METROPOLITAN GOVERNMENT OF NASHVILLE AND DAVIDSON COUNTY

STAFF RECOMMENDATION
1107 Lillian Street
April 16, 2014

Application: New construction – infill
District: Lockeland Springs-East End Neighborhood Conservation Zoning Overlay
Council District: 06
Map and Parcel Number: 08313012800
Applicant: Troy Stackhouse, Odyssey Construction
Project Lead: Sean Alexander, sean.alexander@nashville.gov

Elevations		H2
Date	4/3/14	
Drawn by	J. Feller	Scale 1/8" = 1'-0"

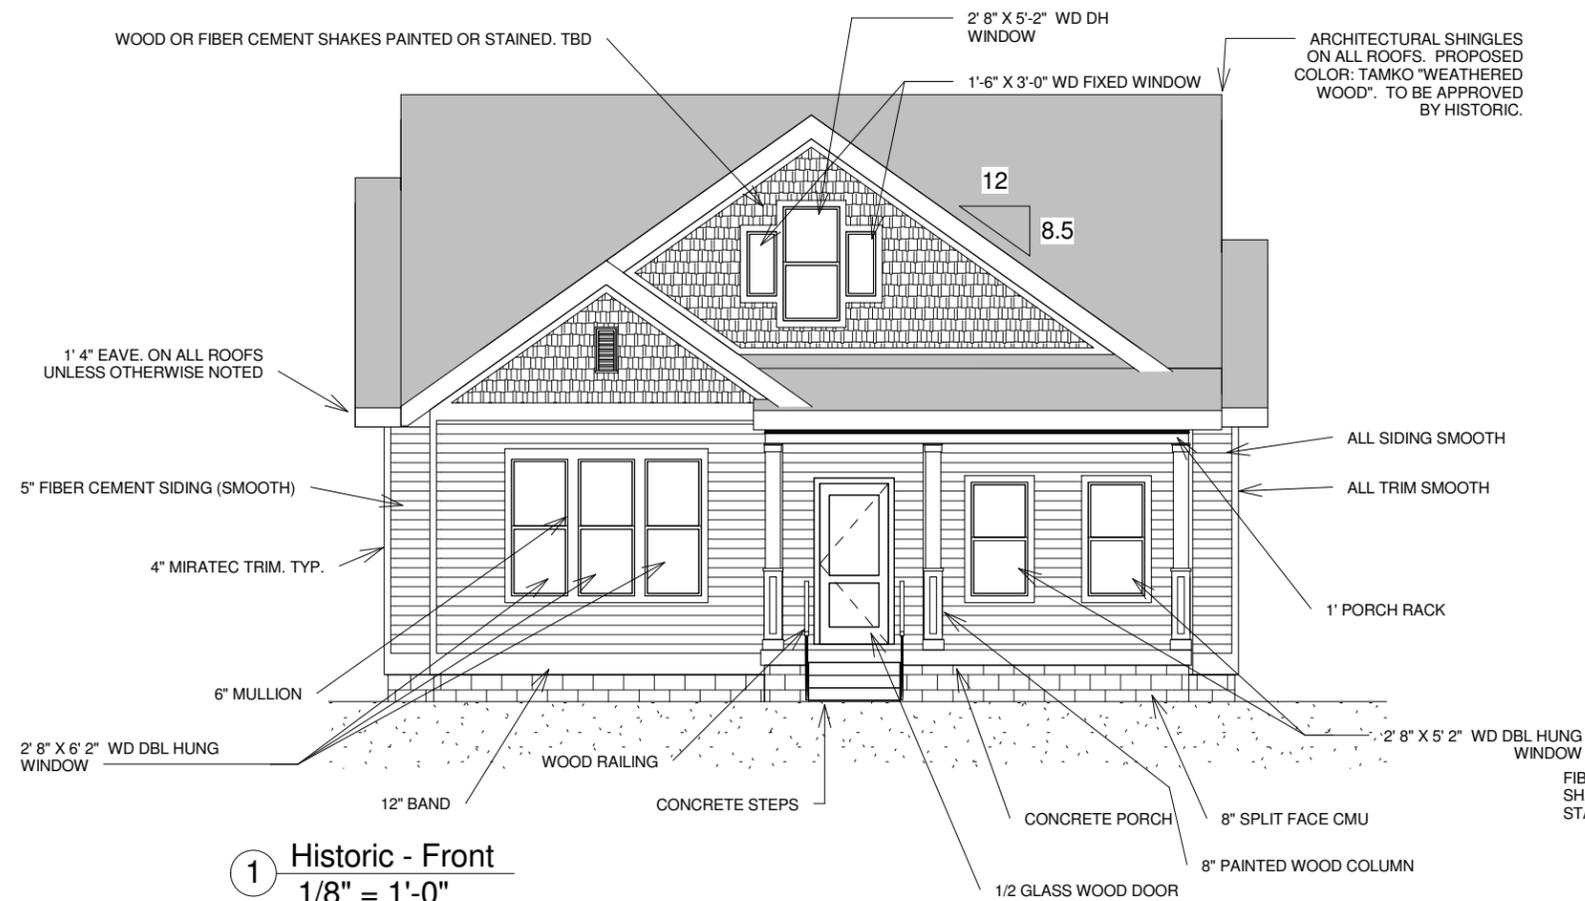
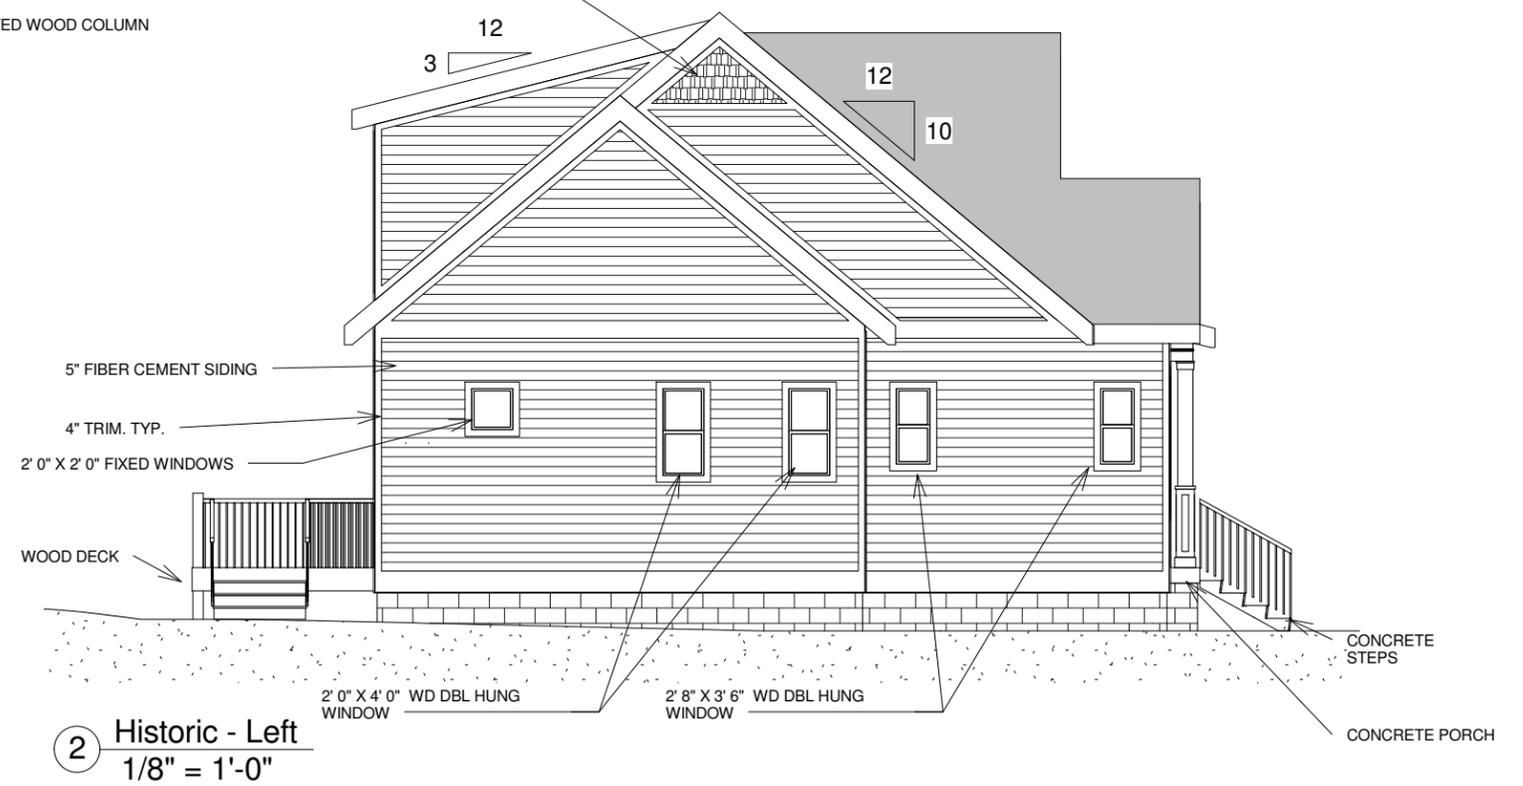
The proposed new building will be a one and one-half story house. The roof height from grade will be twenty-seven feet (27'), with an eave height of twelve feet (12') from grade. The foundation at the front of the house will be twenty-four inches (24") tall, with a ten inch (10") wide water-table band just below the floor level. By comparison, historic houses nearby range between fifteen feet (15') and thirty feet (30') tall. Foundation heights in the 1100 block of Lillian Street are similar as well. Staff finds that the heights will be compatible with surrounding houses.

The primary roof of the new house will be a side-oriented gable with a pitch of 10:12. A smaller front-projecting gable will have a pitch of 8.5:12, and the porch will have a shed-roof with a pitch of 3:12. Staff finds that the roof forms of the new house will be compatible with those of surrounding historic houses and meet guideline section II.B.5.

The windows on the proposed new house are all generally twice as tall as they are wide, thereby meeting the historic proportions of openings. There are no large expanses of wall space without a window or door opening. Staff finds the project’s proportion and rhythm of openings to meet guideline II.B.7.

1 Historic - Rear
1/8" = 1'-0"

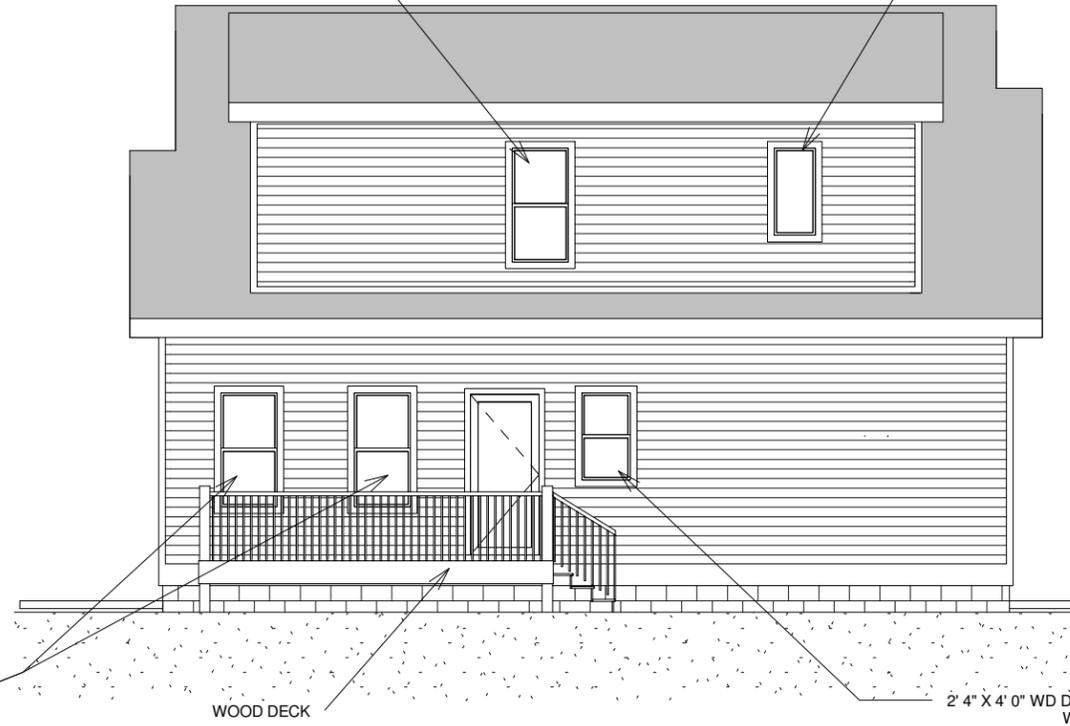
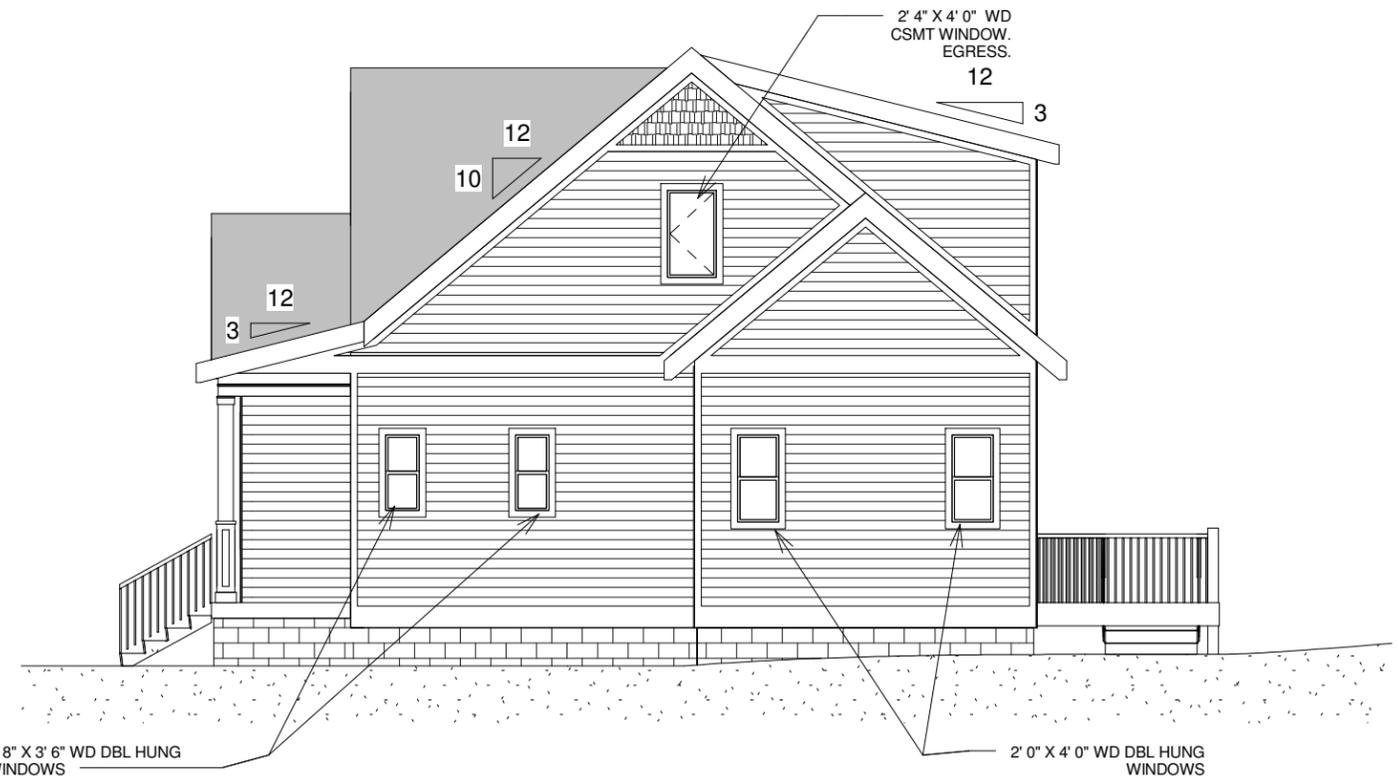
The location of the HVAC will be on the left side façade beyond the midpoint of the house. The meets guideline II.B.9.
